# **STAFF REPORT**

SUBJECT: REQUEST TO ADOPT RESOLUTION NO. 2559, APPROVING AN

INITIAL STUDY AND MITIGATED NEGATIVE DECLARATION (IS/MND), AND MITIGATION MONITORING AND REPORTING PROGRAM (MMRP) UNDER THE CALIFORNIA ENVIRONMENTAL QUALITY ACT (CEQA) FOR A TRANSPORTATION ENHANCEMENT AND ADA IMPROVEMENT PROJECT AT PALOS VERDES DRIVE NORTH (PVDN) AND LONDON LN. (DAPPLEGRAY ELEMENTARY SCHOOL ENTRANCE); AND, TO SOLICIT BIDS FOR THE PROJECT WITH FUNDING BY A "MEASURE M FUNDING AGREEMENT MULTI-YEAR SUB REGIONAL PROGRAM" WITH THE LOS ANGELES COUNTY METROPOLITAN

# CITY OF ROLLING HILLS ESTATES CALIFORNIA CONSTRUCTION PLANS

SIGNING AND STRIPING PLAN

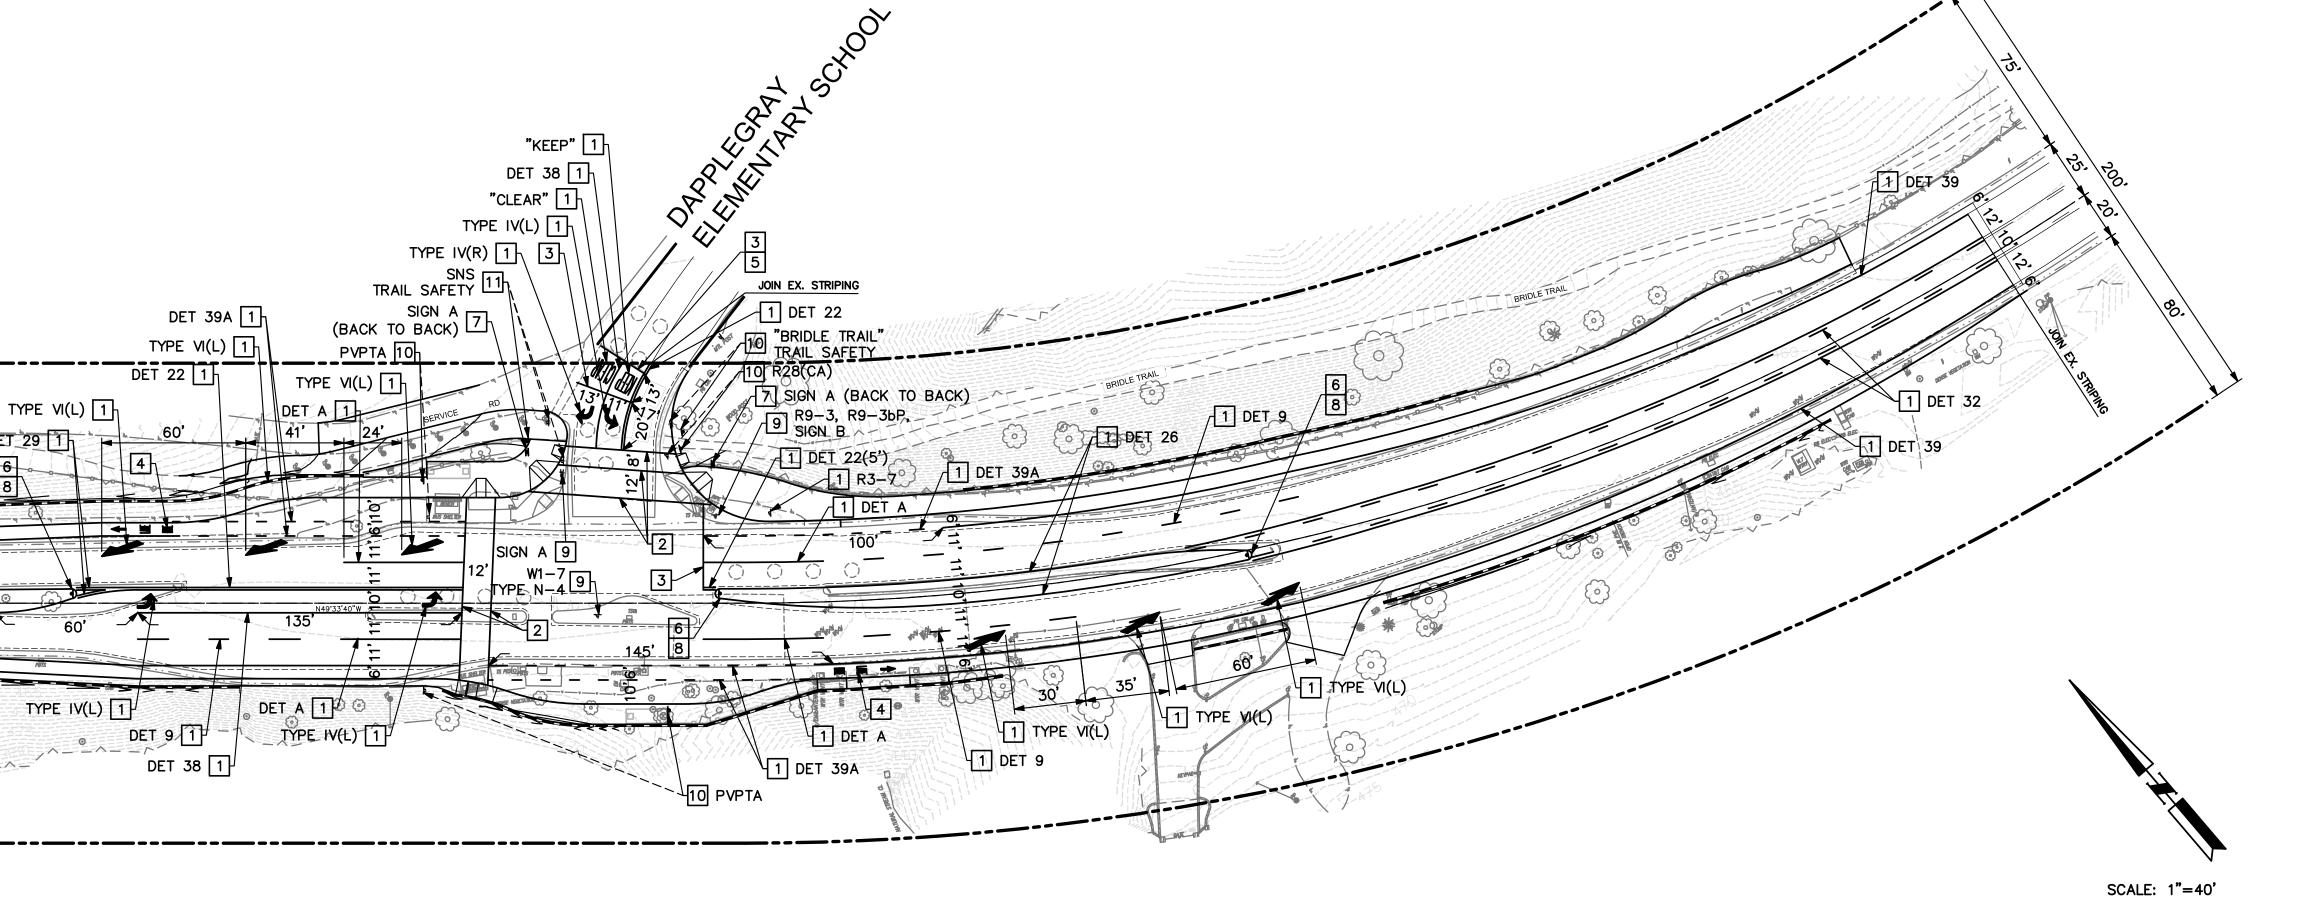
**Response:** Comment and request noted. Pedestrians, cyclists, and equestrians will be accommodated by new sidewalks, a marked Class II bicycle route, and a re-aligned equestrian path along PVDN. The City

acknowledges that removing the raised median at the crosswalk on the west side of the intersection (see Exhibit A, Sheet 14, Signing and Striping Plan) eliminates a perceived "safety island;" however, the cross-section's geometry and available right-of-way required this design solution. The existing median island was only 4' in width which is not wide enough to function as a refuge island. As can be seen on the retaining wall exhibits, widening this street segment made it necessary to cut back existing fill slopes. To create sufficient space for a safety median, additional excavation would be needed, resulting in taller, more costly, and aesthetically unappealing retaining walls. In part to address aesthetic concerns, the City has directed that the retaining walls' heights be minimized. In order to address pedestrian concerns, the City will monitor signal timing and adjust it as needed.
